DESIGN REVIEW BOARD RECOMMENDATION MEETING | CAPITOL HILL TOD

SECOND EAST DESIGN REVIEW BOARD MEETING ON OCTOBER 11, 2017

FIRST RECOMMENDATION MEETING PRIORITIES & BOARD RECOMMENDATIONS

RECOMMENDATION 2 | ISOMETRIC SITE VIEW LOOKING EAST

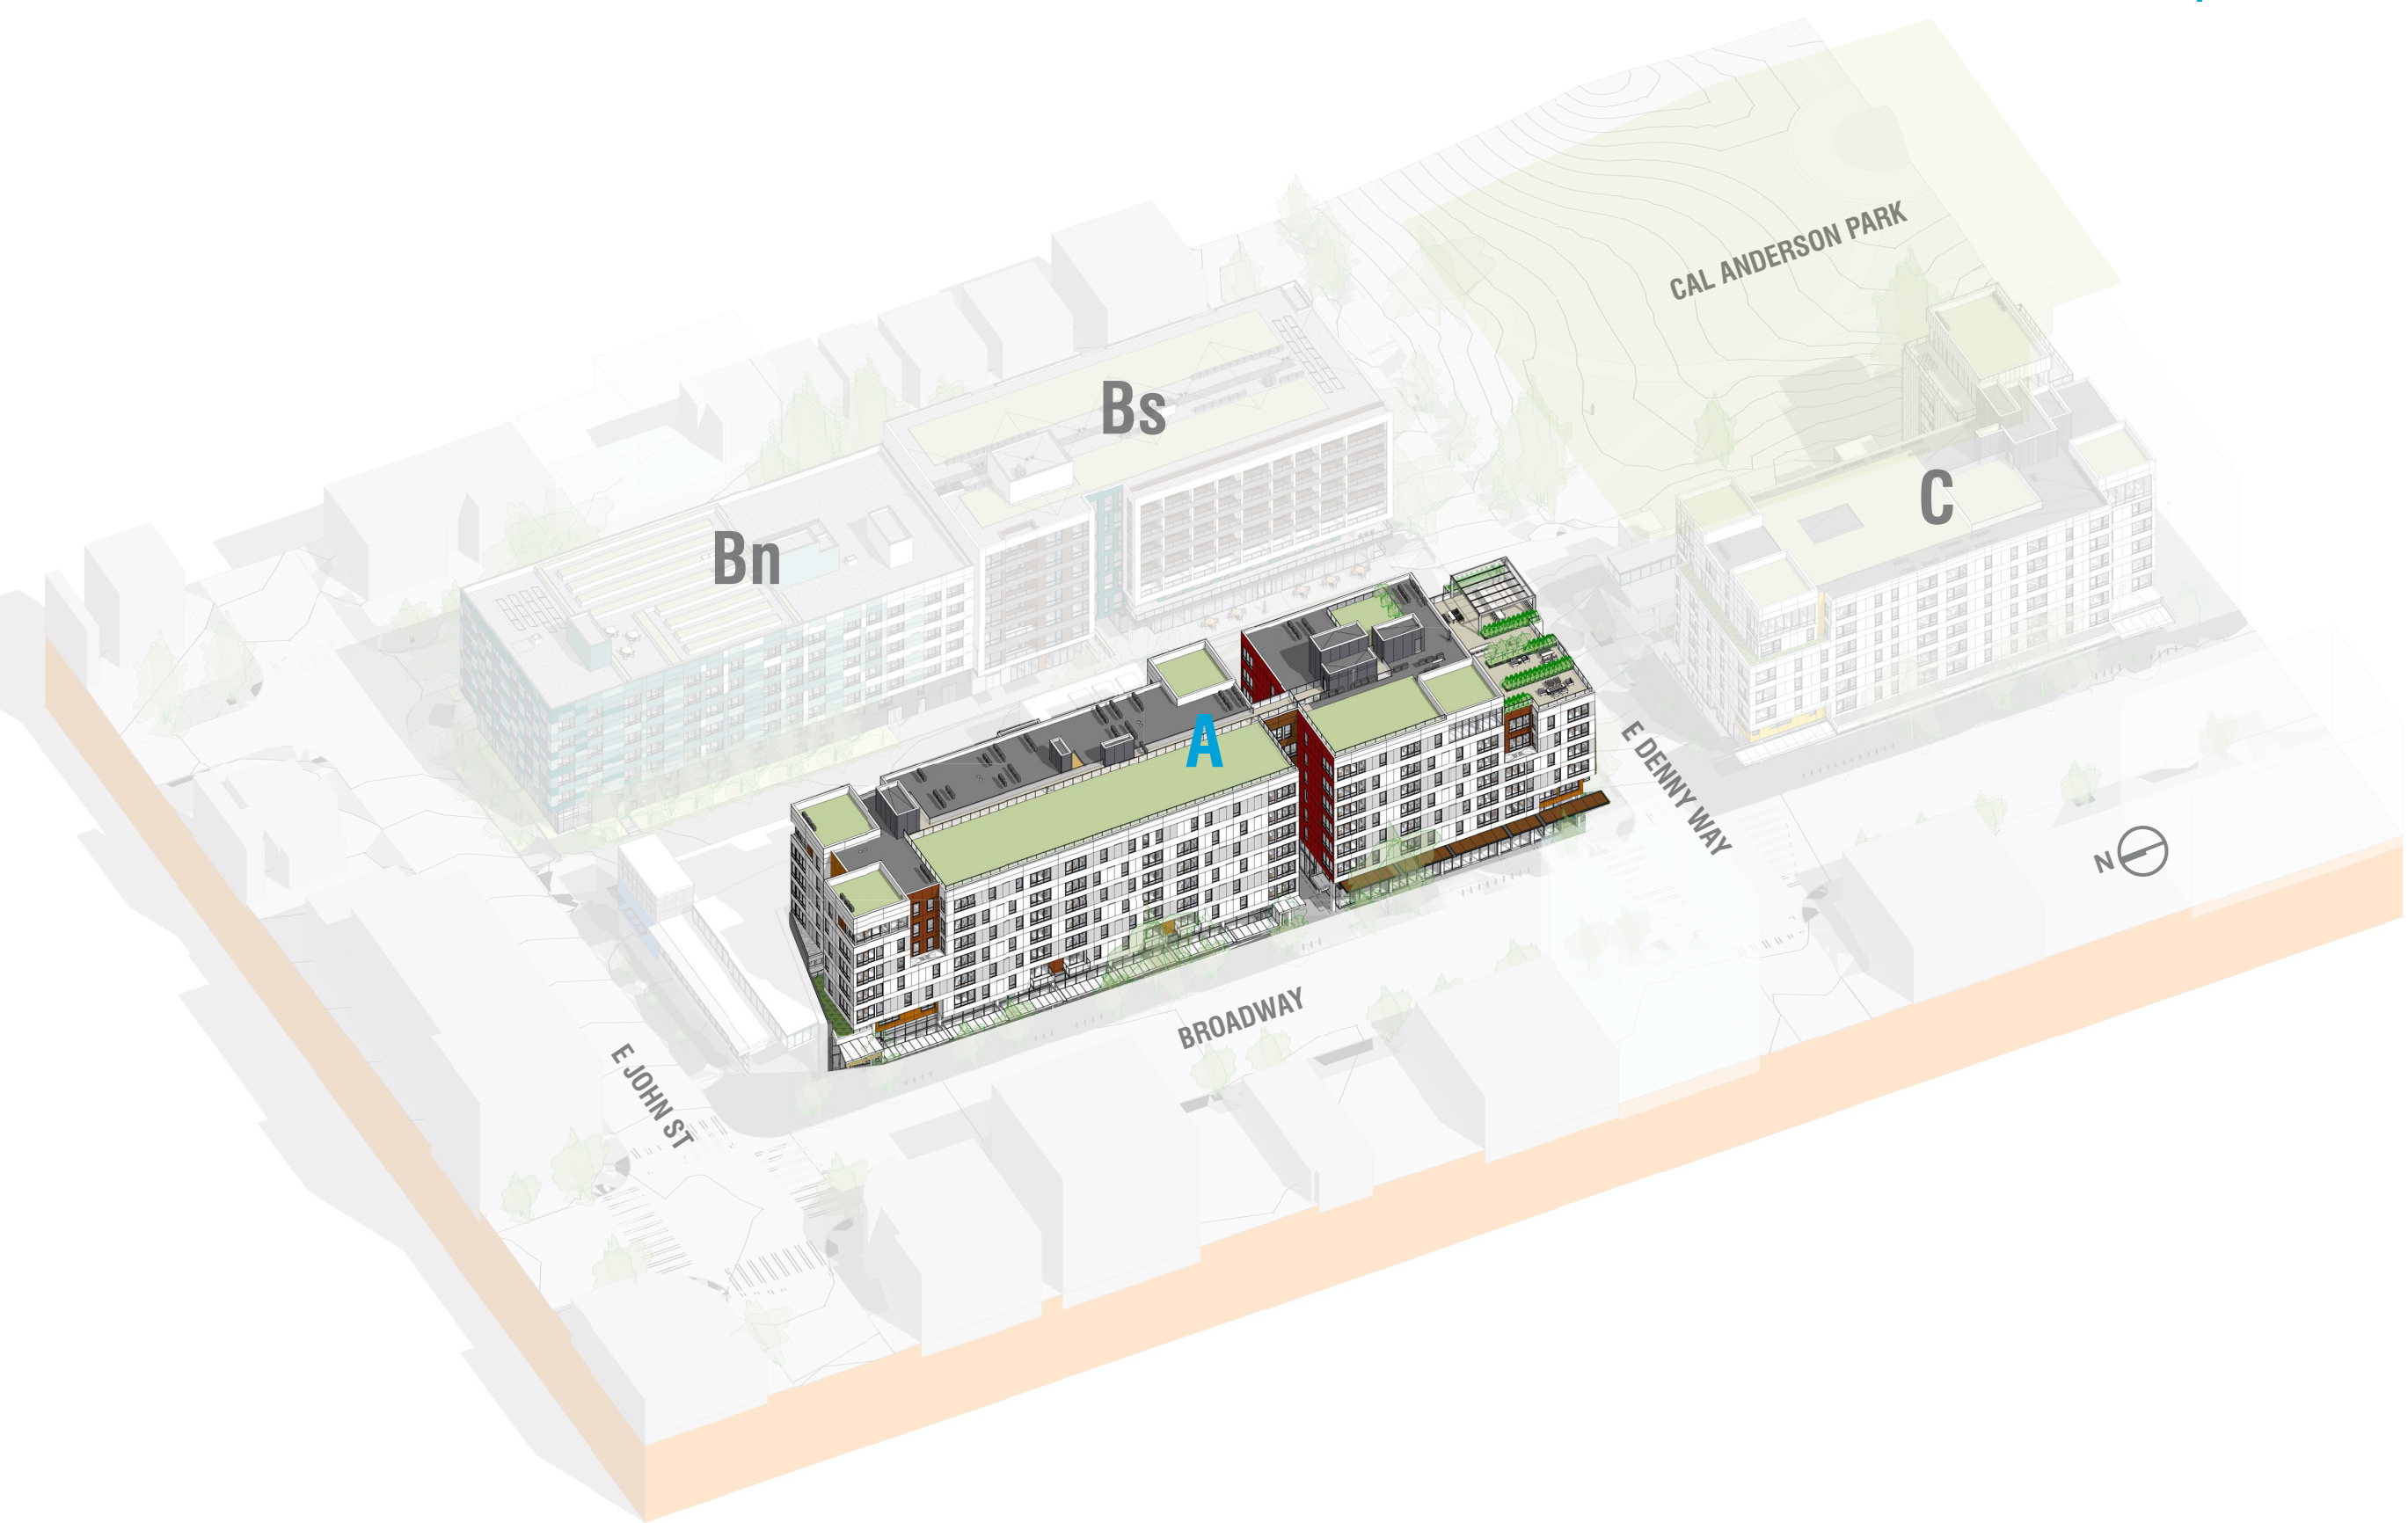
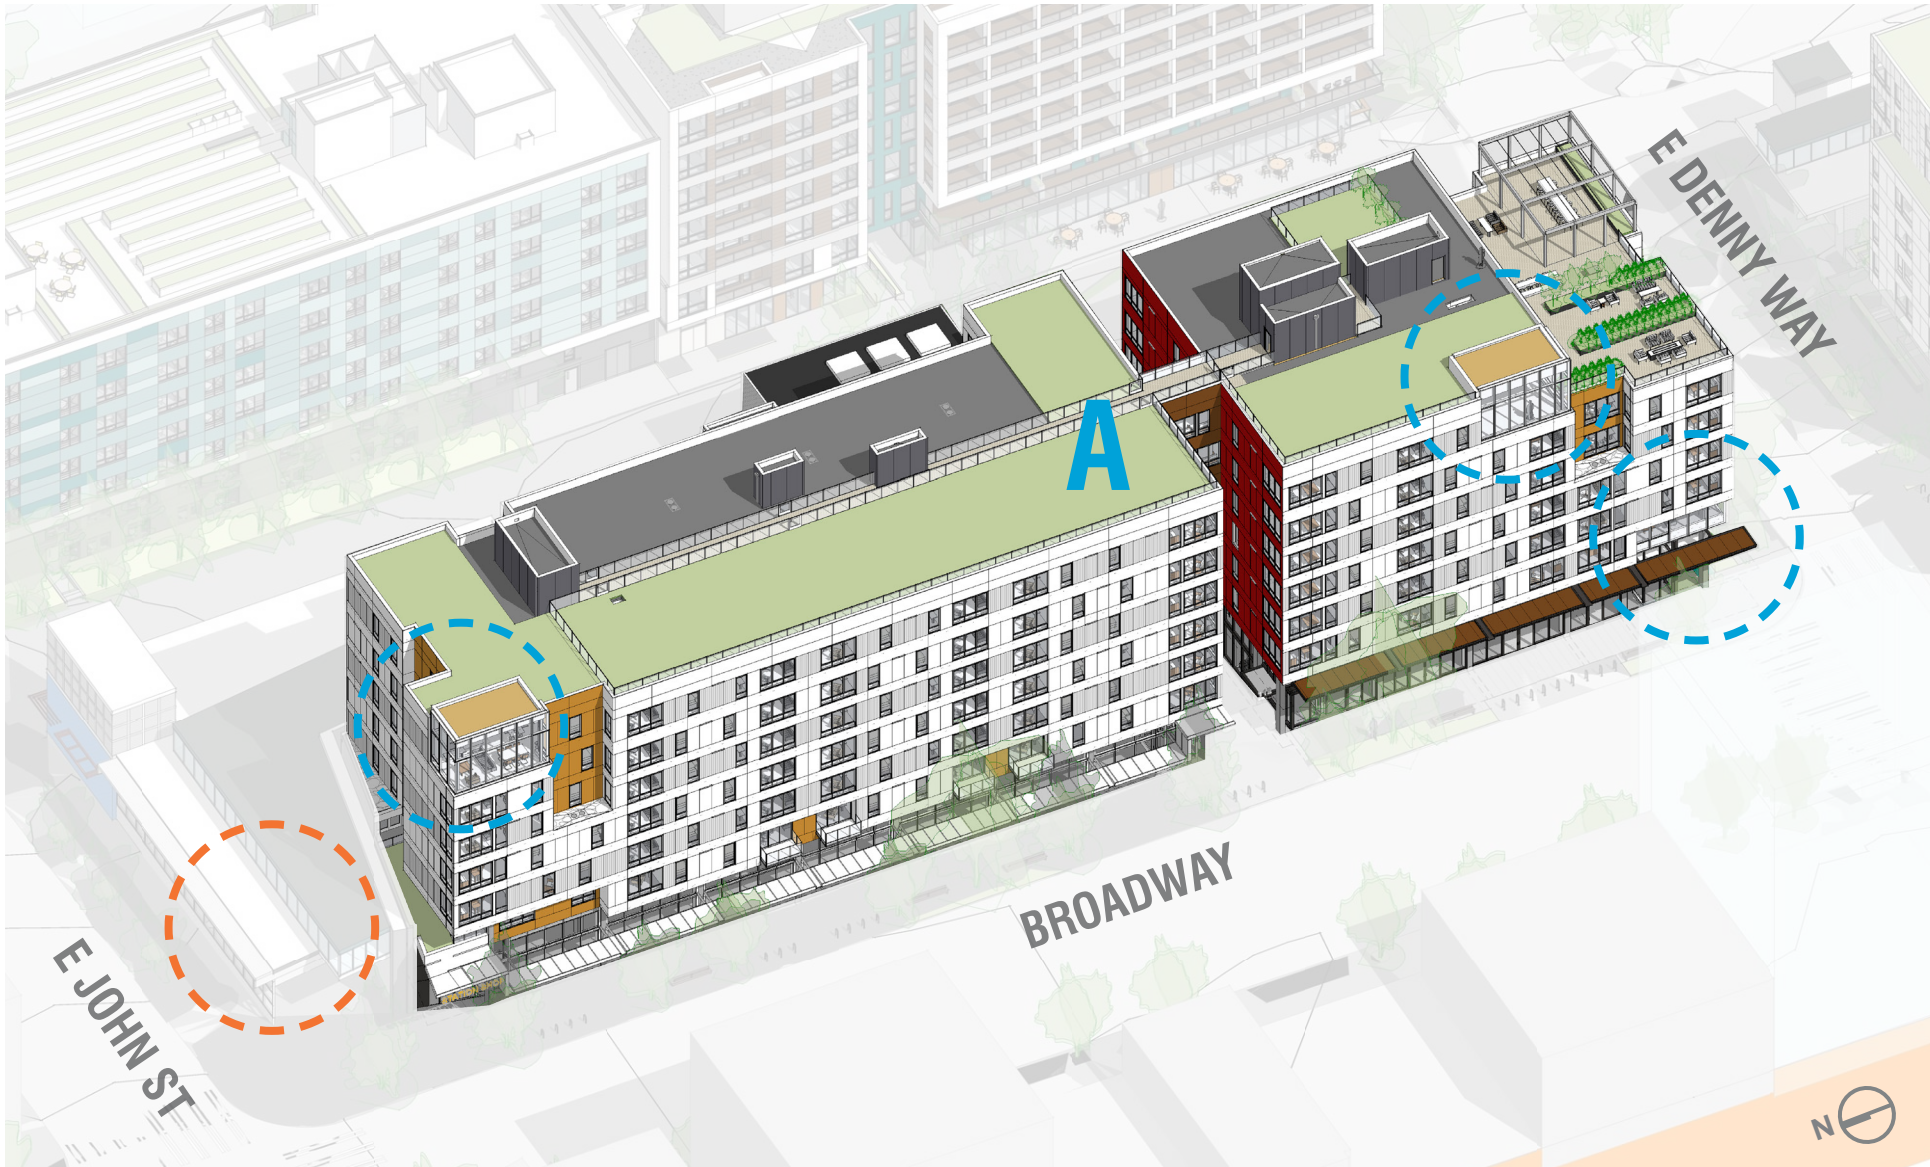
2) The Board was concerned that the effect of the “lantern” elements were not fully realized and should be expressed further to create strong focal points and create a strong architectural concept for the buildings along Broadway. These lantern elements should read as glassy boxes that have a higher proportion of glazing to allow them to better read as lit beacon elements [119, 131]. Resolution of this design element will better reinforce the contemporary, shifting and subtractive language shown at EDG at the Broadway building corners, midblock, tall ground floors, and expressing the upper setbacks and lanterns. (DC2-C & D; DC2-S-V-iii) See also Building C.

RESPONSE:
Blue dashed areas indicate where the “lantern” elements have been amplified on Building A. Orange dashed area indicates a “lantern” element already present at the existing North Station Entry.

RECOMMENDATION 2 | 'CONCEPT' "LANTERN" LEVEL L07 PLAN

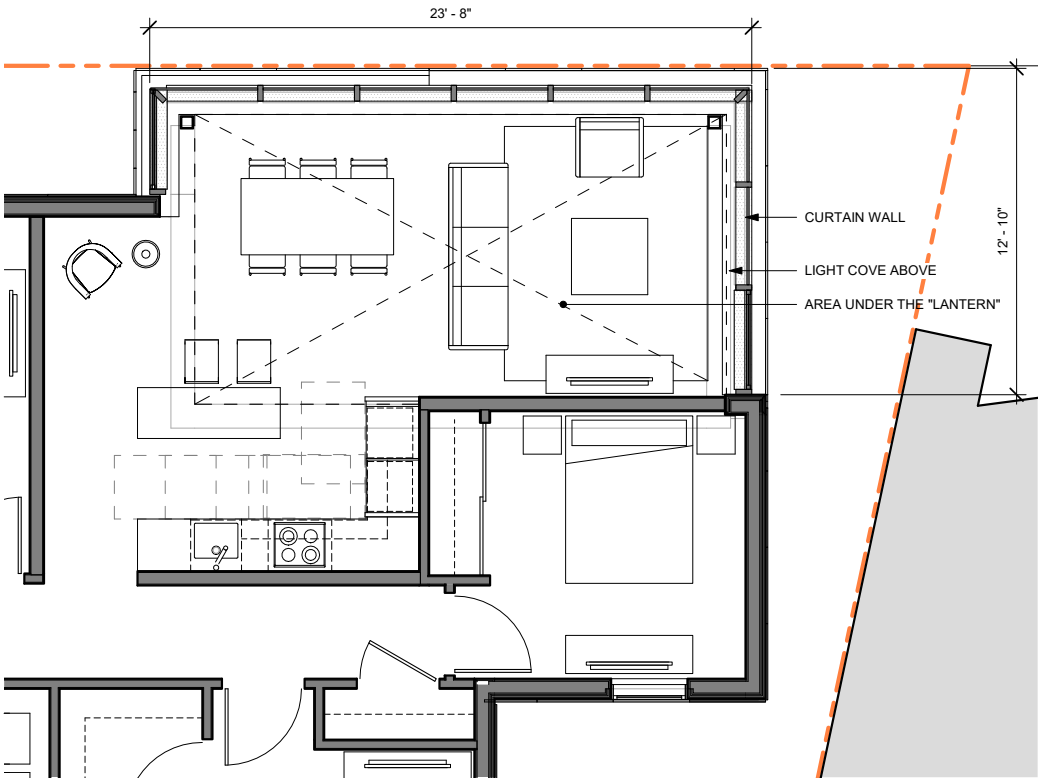
2) The Board was concerned that the effect of the “lantern” elements were not fully realized and should be expressed further to create strong focal points and create a strong architectural concept for the buildings along Broadway. These lantern elements should read as glassy boxes that have a higher proportion of glazing to allow them to better read as lit beacon elements [119, 131]. Resolution of this design element will better reinforce the contemporary, shifting and subtractive language shown at EDG at the Broadway building corners, midblock, tall ground floors, and expressing the upper setbacks and lanterns. (DC2-C & D; DC2-S-V-iii) See also Building C.

RESPONSE:
Additional information regarding the proposed “lantern” construction is described at the left to resemble a “glassy box” related to the existing station entry below.

RECOMMENDATION 2 | LANTERN PRECEDENTS, MATERIALS AND DETAILING| BUILDING A

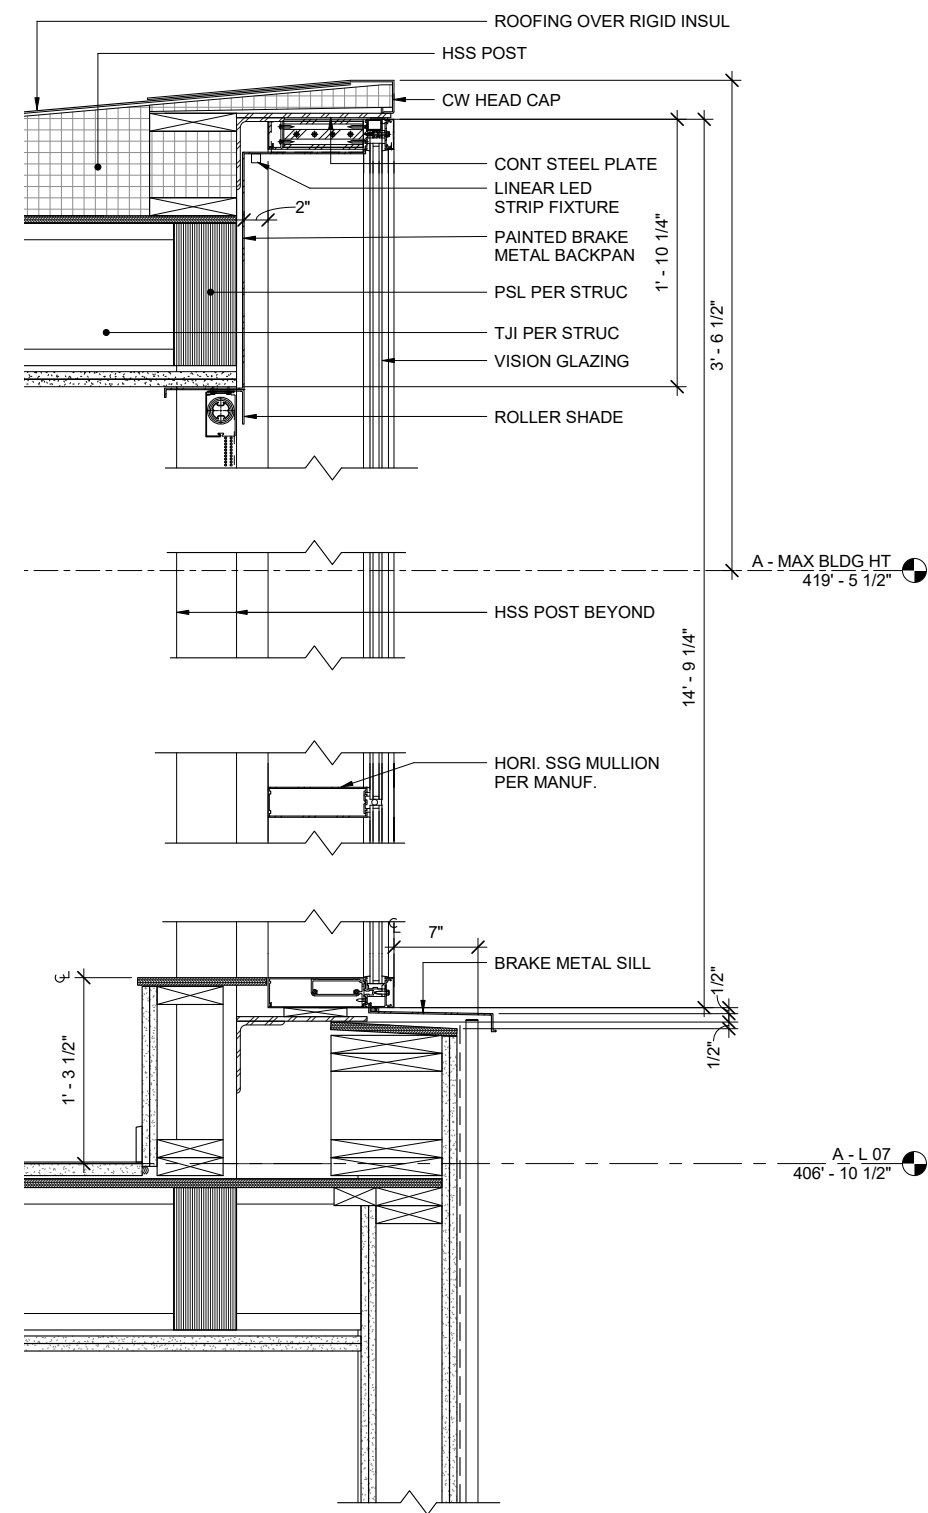
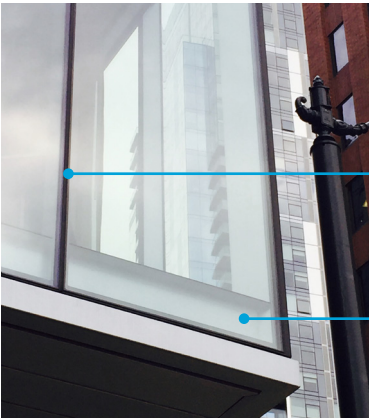
2) The Board was concerned that the effect of the "lantern" elements were not fully realized and should be expressed further to create strong focal points and create a strong architectural concept for the buildings along Broadway. These lantern elements should read as glassy boxes that have a higher proportion of glazing to allow them to better read as lit beacon elements [119, 131]. Resolution of this design element will better reinforce the contemporary, shifting and subtractive language shown at EDG at the Broadway building corners, midblock, tall ground floors, and expressing the upper setbacks and lanterns. (DC2-C & D; DC2-S-V-iii) See also Building C.

RESPONSE:
To achieve a "glassy box" lantern effect during the day, the selection of glass is proposed to have a a "light silver" reflective film on the interior (#2) surface of the insulated glass panels. This 30% (+/-) reflective film offers both transparent glass and form to the surface at the same time depending on the angle of view and daylight conditions. Please see examples of this to the left. Other images on the left show examples of "shadow box" detailing at the curtain wall heads and sills to amplify the glass box expression.
